# POST HURRICANES EVALUATION OF THE SUBMERGED REEF BALL BREAKWATER AT THE MAYAN PALACE RESORT, QUINTANA ROO, MEXICO

October 2005

This letter report presents the results of site visits performed in August 2005 for the submerged artificial reef breakwater at the Mayan Palace Resort. This project is located north of Playa del Carmen in the Mayan Riviera corridor south of Cancun, Mexico. Reference the October 1992 original design recommendations report titled "Recommended Design Layout, Installation and Monitoring for the Submerged Reef Ball Breakwater at the Mayan Palace Resort, Quintana Roo, Mexico." The site visits for this report were performed after the project was impacted by Hurricane Ivan in 2004 and Hurricanes Emily in 2005.

Figure 5. Post Hurricane Ivan Survey Performed by Marenter

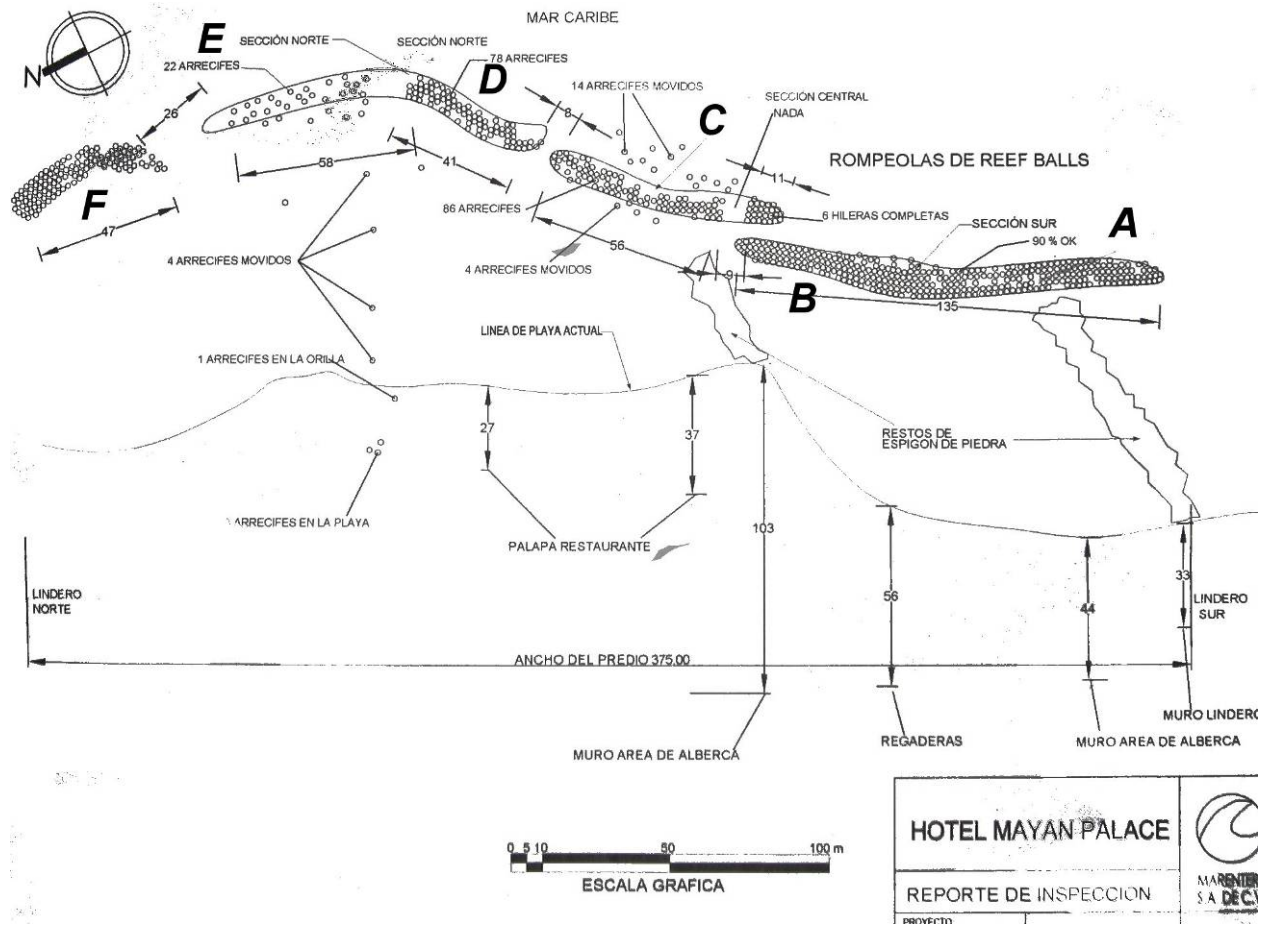
Figure 5 shows the post Hurricane Ivan survey performed by Marenter. The different regions of the breakwater are labeled **A** through **F** from south to north as shown in Figure 5 and subsequent Figures, to provide a numbering system to assist with discussions of the performance of different sections of the breakwater system.

Figure 6 shows an aerial photograph taken after construction of the breakwater, and provides a good comparison of the as-built condition compared to the post-Hurricane Ivan condition shown in the survey in Figure 5 (directly above Figure 6 for comparison).

Figure 7. Post-Hurricane Ivan Aerial Photograph

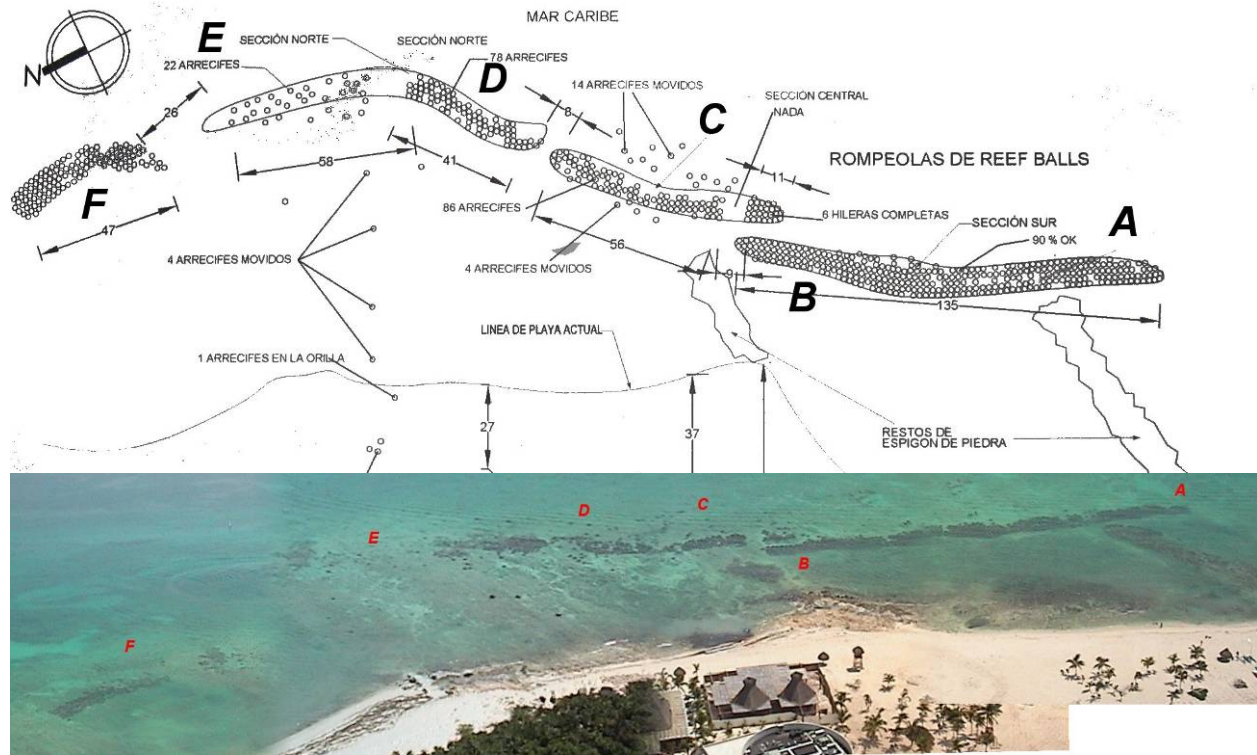
Figure 7 shows an aerial photograph taken after Hurricane Ivan, and provides good comparisons to the as-built photographs and to the post-Hurricane Ivan condition shown in the survey (reproduced as part of Figure 7 for comparison). Figure 8 shows a close-up aerial photograph of all of the breakwater regions after Hurricane Ivan, except for Region F which is further north of the area photographed.

Figures 7 and 8 show that the Reef Ball breakwater regions A and B remained unchanged after impacted by Hurricane Ivan. A close-up aerial photograph of that area is shown in Figure 9. This was the first breakwater portion to be constructed, and inspection of the units indicates that the concrete quality, fabrication of anchoring sleeves, and anchoring was satisfactory. Hence this part of the breakwater performed well under the wave attack due to the major hurricanes. Figure 10 shows the overlap of the Reef Ball breakwater at regions B and C. This overlap is greater than necessary, and was not the most effective use of the Reef Ball units.

Figures 7 and 8 show that the Reef Ball breakwater regions C, D, and E did not survive well after impacted by Hurricane Ivan. A close-up aerial photograph of that area is shown in Figure 11. This breakwater portion was constructed after regions A and B, and inspection of the units indicates that the concrete quality, fabrication of anchoring sleeves, and anchoring was not satisfactory. Hence this part of the breakwater failed under the wave attack from the major hurricanes. Inspections revealed poor quality concrete, omission of the concrete additives, omission or unusable anchoring sleeves, and the resulting lack of any anchoring on most of the units in this region. This resulted in movement and breakage of many of the units in this area, as shown in the aerial photographs and Marenter survey.

**Figure 11. Aerial Photograph – Region D-E**

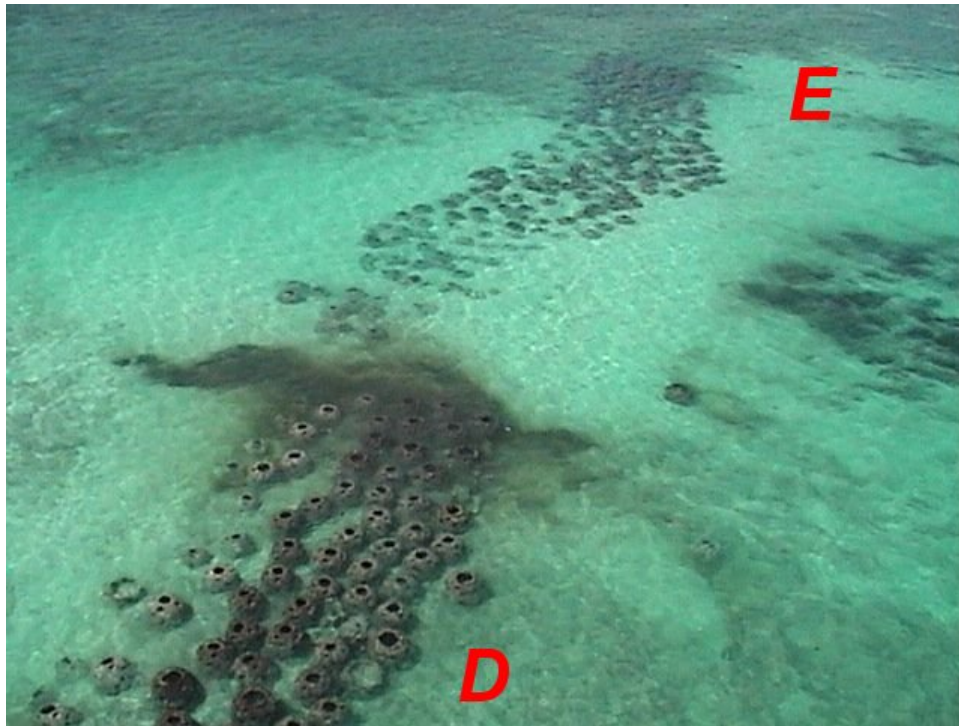
Field inspections showed that the best constructed regions of the breakwater were regions A and B, with significantly decreasing quality control for the other parts of the breakwater. Major problems were the poor concrete quality (no additives), fabrication (no useable anchor rod sleeves), and installation (no fiberglass anchors used, often due to the lack of adequate anchor sleeves due to poor fabrication). In addition, the overall crest height of the breakwater was not at a sufficiently high or uniform elevation to provide the effectiveness for wave attenuation that was recommended.
